UNITED STATES  
DEPARTMENT OF THE INTERIOR  
BUREAU OF LAND MANAGEMENTFORM APPROVED  
OMB NO. 1004-0137  
Expires: January 31, 2018**SUNDRY NOTICES AND REPORTS ON WELLS**  
*Do not use this form for proposals to drill or to re-enter an abandoned well. Use form 3160-3 (APD) for such proposals.***SUBMIT IN TRIPLICATE - Other instructions on page 2**

Ref No	MRLS (7/2017)	Well No	#2
Well Name	Tonto Federal	API #	30 025 33500
County	Lca	Prop #	13589
State	New Mexico	Zone	009200e
Spud Date	7/5/1996		1900 FEL & 000 FEL
Well	3 661"		Sec 12 T19S R32E

**Permanent Abandonment of Federal Wells**  
**Conditions of Approval (LPC Habitat)**

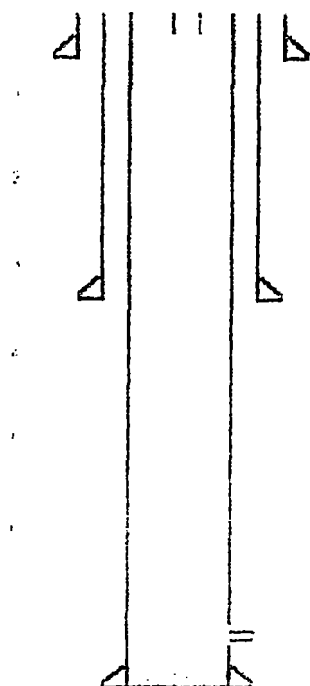
\*\* BLM REVISED \*\* BLM REVISED \*\* BLM REVISED \*\* BLM REVISED \*\* BLM REVISED \*\*

- Set 5 1/2" CIBP @ 7200'. Circulate hole w/ MLF. Pressure test csg. Spot 35 sx cmt @ 7200-6850'. WOC & Tag
- Spot 25 sx cmt @ 5950-5780'. WOC & Tag (Delaware)
- Spot 40 sx cmt @ 3500-3445'. WOC & Tag (Yates & Shoe) 3500' - 3115'
- Perf & Sqz 50 sx cmt @ 2855-2755'. WOC & Tag 2855' - 2727'
- Perf & Sqz 50 sx cmt @ 1700-1600'. WOC & Tag (T/Salt) 1700' - 1580'
- Perf & Sqz 120 sx cmt @ 560'-Surface.
- Cut off well head, verify cmt to surface, weld on Below Ground Dry Hole Marker.
